Figure 9
Roof terminal VTK06 90-200

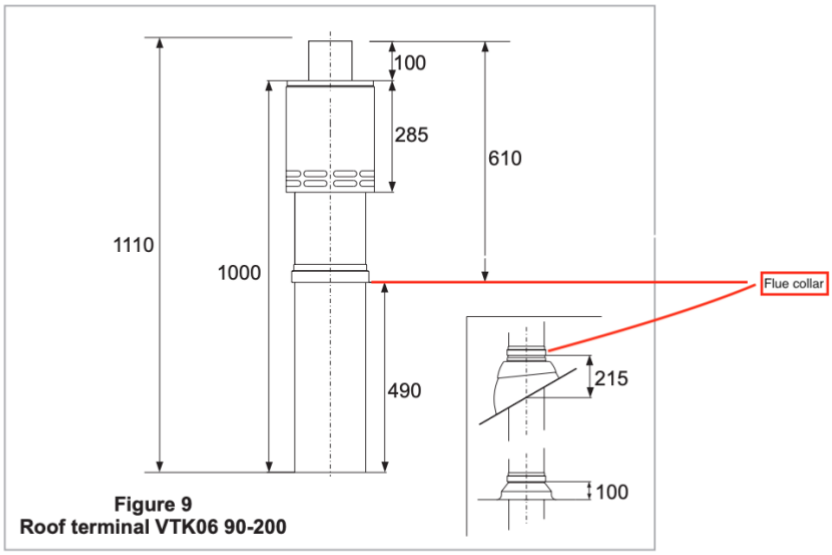
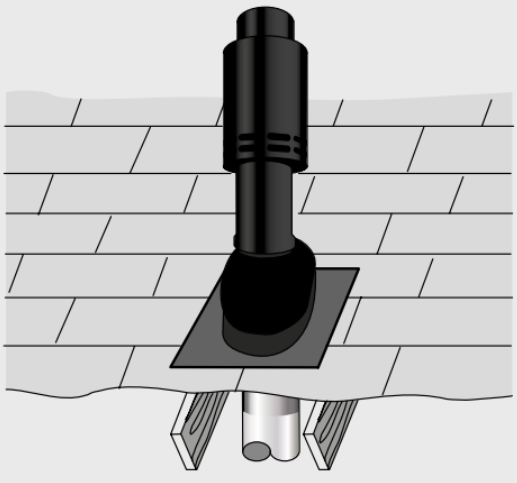
3: Please can you provide flue technical details required to show the type proposed and its noise output.

Please see below images of the flue.

Operating sound levels inside are 51.1db the manufacturer does not give a sound level for the external flue but it would be fair to assume it is approximately the same.

The flue collar has been marked in red. From the pitch of the roof to the top of the terminal will be 815mm, this includes the flashing kit.

Note: Range of pitch 22°-45°.
